Access Compliance Report Public Rights-of-Way (Pedestrian Signals)

Main Street: **MADISON_AVE** Cross Street: **NEWLAND_ST** Location: **NW**

ADA ID: **SGRK210929122253** Signal Type: **One Push Button-Non APS** Overall Compliance: **No** Severity Scores: **BTN 1: 35** **BTN 2: N/A** **No BTN: N/A**

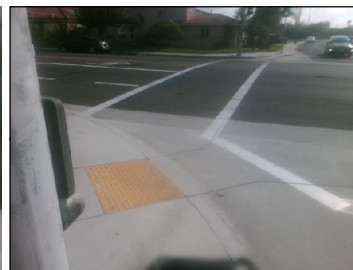
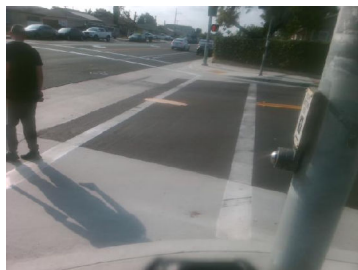
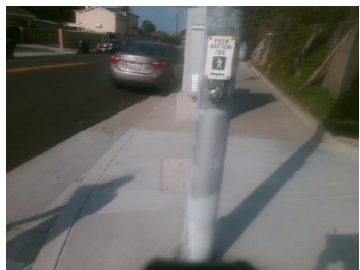
OC Std/PROW: **R404.2, MUTCD 4e.08**

Possible Solutions: Replace Signal Push Button With APS Button. Remove and Replace Clear Space.
